UNITED STATES PATENT AND TRADEMARK OFFICE

Office Action Summary

10/736,656

DETAILED ACTION

FIG. 3

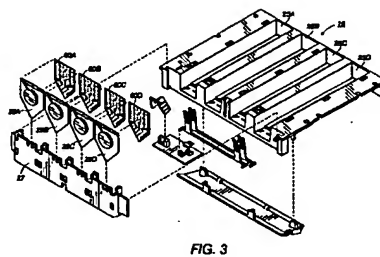
- {claim 1} A solid ink melt assembly for use in a phase change printer (figure 3); a drip plate with first and second sides (figure 3, reference 60A-D); a lower portion of the plate is shaped to form a drip point (figure 4, reference 52); a heater mounted to the first side of the plate and in direct contact with the plate without any insulating layer therebetween (figure 3, reference 29A-D); wherein the second side of the drip plate is directly exposed to ink sticks for melting (figure 3)

- {claim 13} a retaining clip to prevent large scale separation of heater elements from the drip plate (figure 3, reference 27)
- {claim 14} An ink loader for use in a phase change printer (figure 3); at least one channel having an entry end and an exit end (figure 3, reference 25A-D); a melt assembly (figure 3); a metallic drip plate with first and second sides, wherein the drip plate is formed so as not to allow fluid to pass through from the second side to the first side (figure 3, reference 60A-D); a heater mounted directly to the first side without any insulating layer therebetween (figure 3, reference 29A-D)

- {claim 19} wherein at least one of the drip plates and the melt plate is made from a non ferrous metal
- {claim 21} A phase change ink printer (figure 3); an ink loader for use in a phase change ink printer comprising at least one channel having an entry end and an exit end (figure 3, reference 25A-D); a melt assembly, which includes a metallic drip plate with first and second sides, wherein the lower portion of the plate is shaped to form a drip plate (figure 3, reference 60A-D); a heater mounted directly to the first side without any insulating layer therebetween wherein the drip plate is formed so as not to allow fluid to pass through from the second side to the first side (figure 3, reference 29A-D)
